THE HIGHLAND COUNCIL

Committee: North Planning Applications Committee

Report Title: 16/01842/PIP – Land 255 m East of Culcairn Farmhouse, Station Road, Evanton

Report By: Area Planning Manager – North

PROJECT NO	DRAWING NO
1340	FL - 01

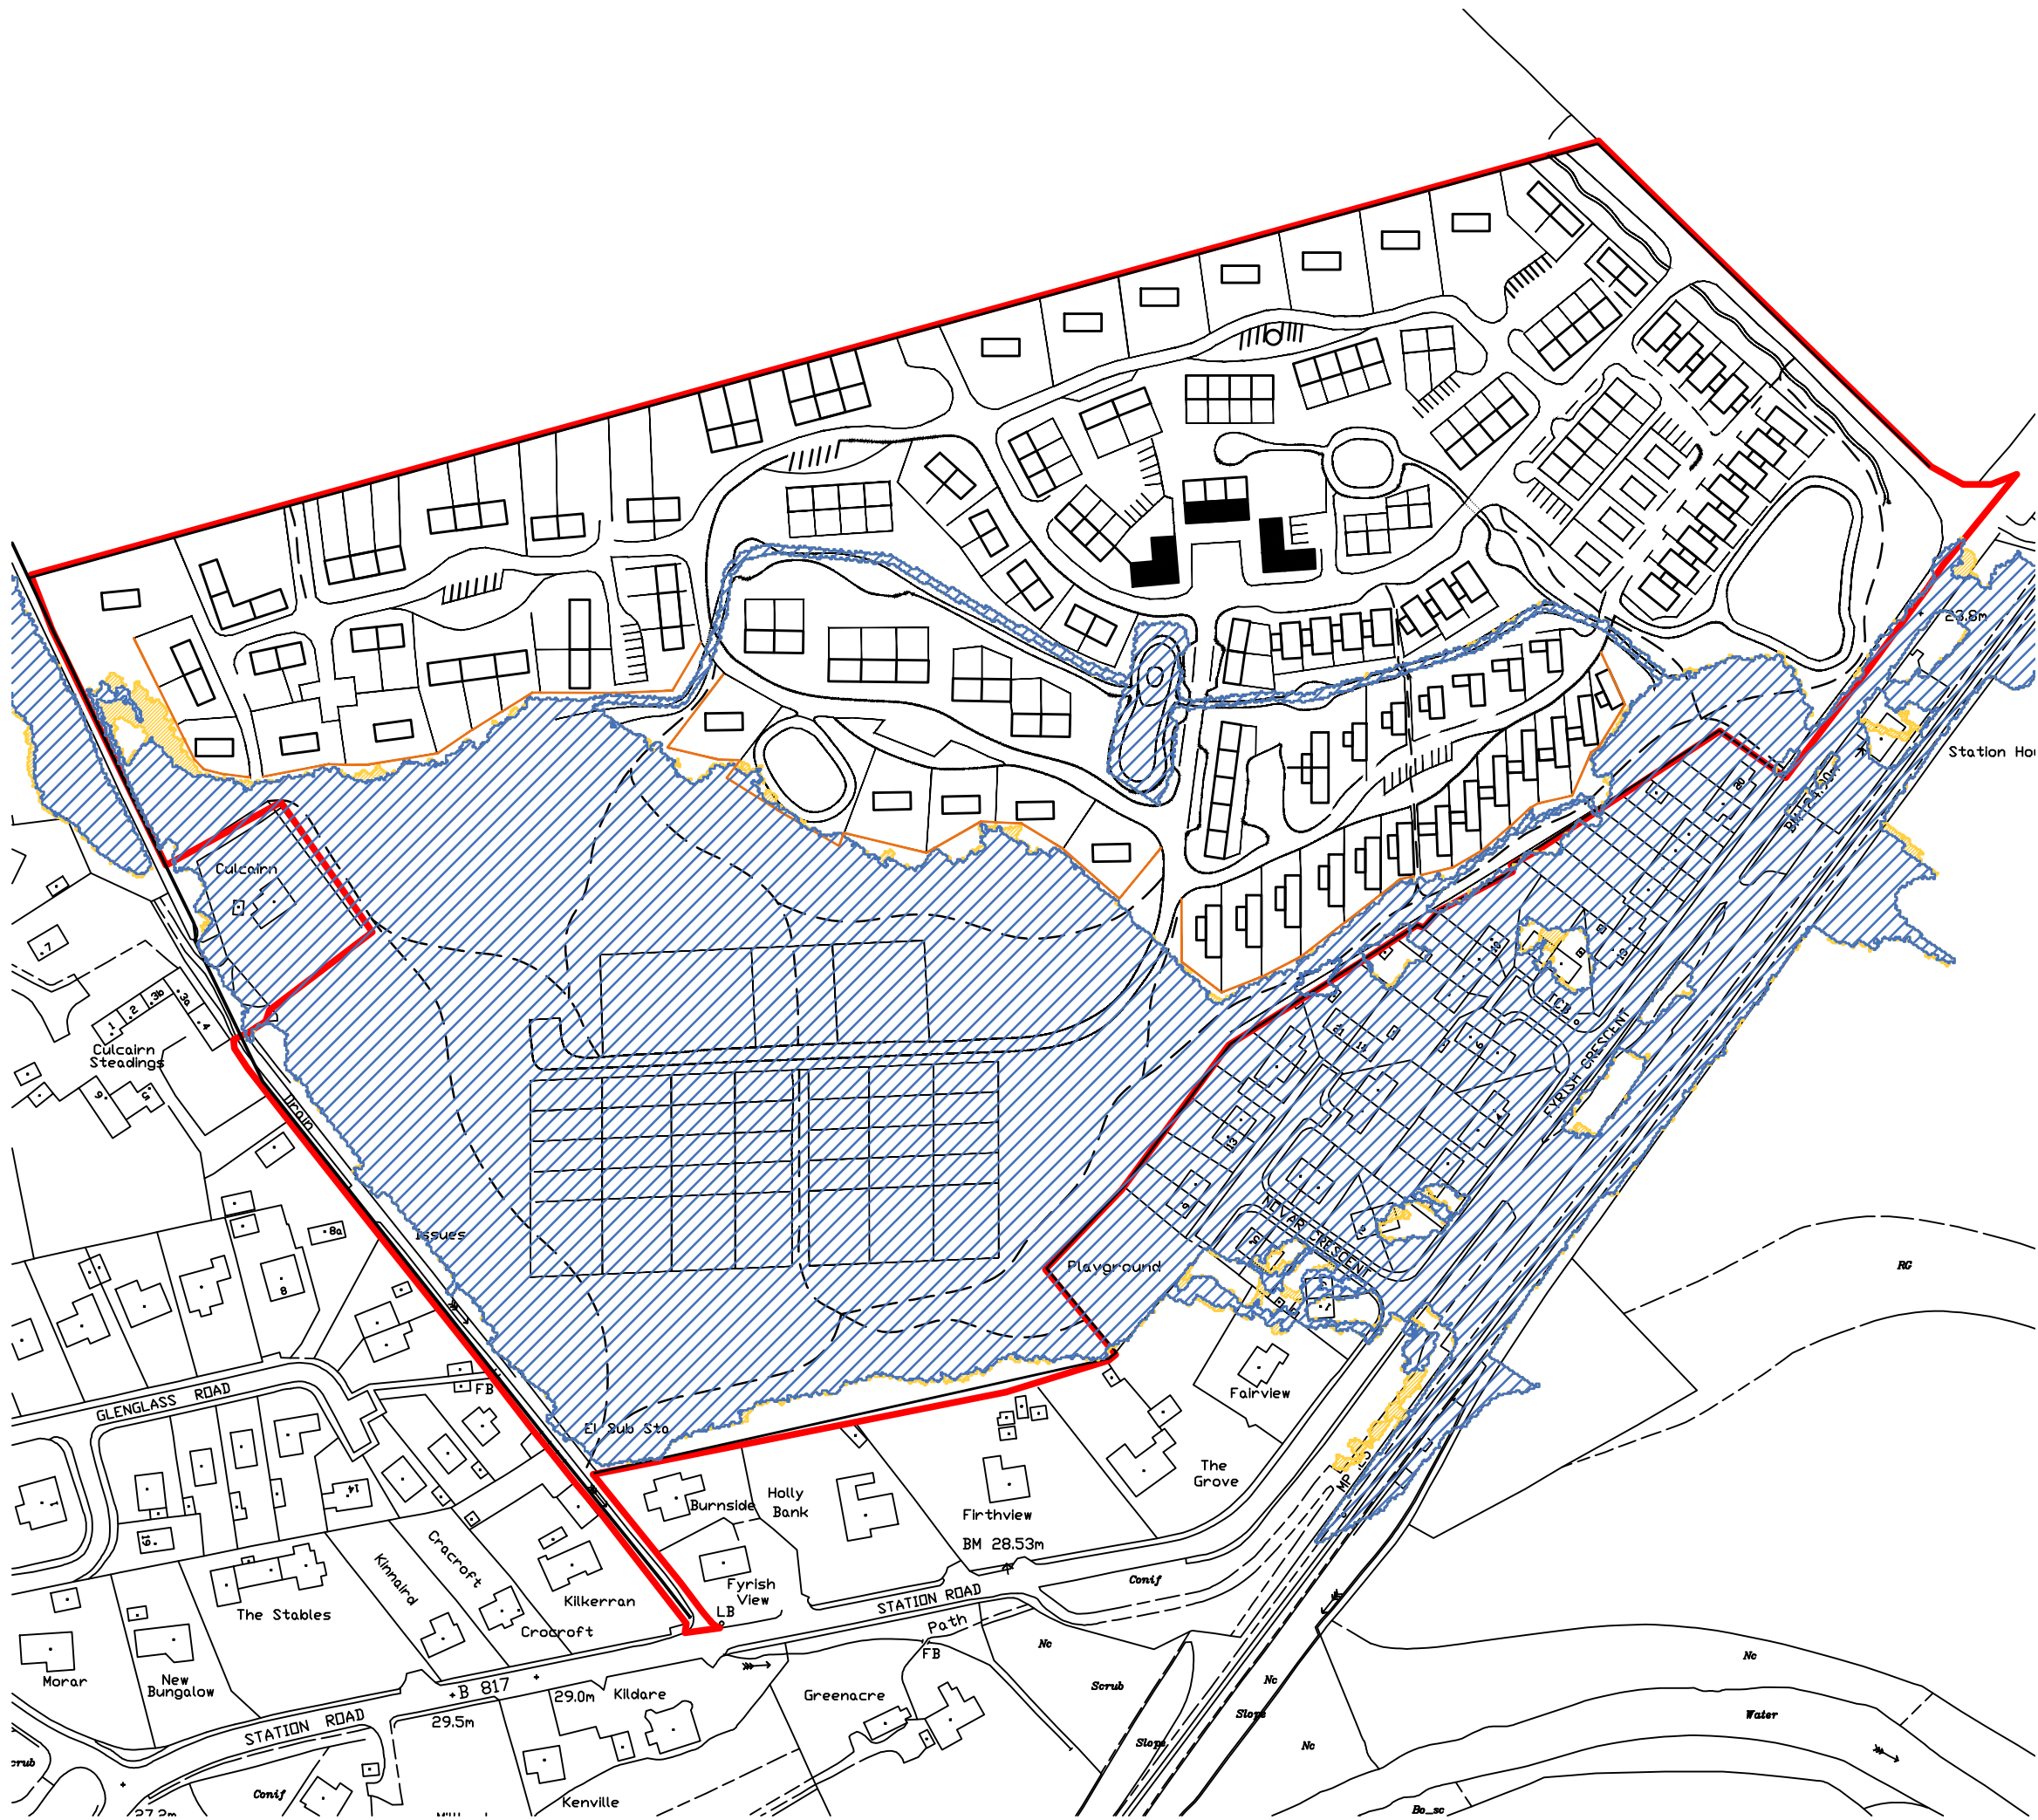
1. The development layout should be in accordance with the amended Site Plan drawing 1340/FL-01 to ensure that properties and private gardens are located outwith the predicated fluvial overland flow routes and flood storage areas.

3. Secure principles of revised site layout (1340/FL-01) where no development, including property boundaries and private gardens are to be within the predicted 1 in 200 year plus climate change flood extent.

9. Any details pursuant to Condition 1 above shall be in accordance with the amended Site Layout drawing ref. 1340/FL-01 to ensure that no development, including property boundaries and private gardens are located within the predicted 1 in 200 year plus climate change flood extent, fluvial overland flow routes and flood storage areas.
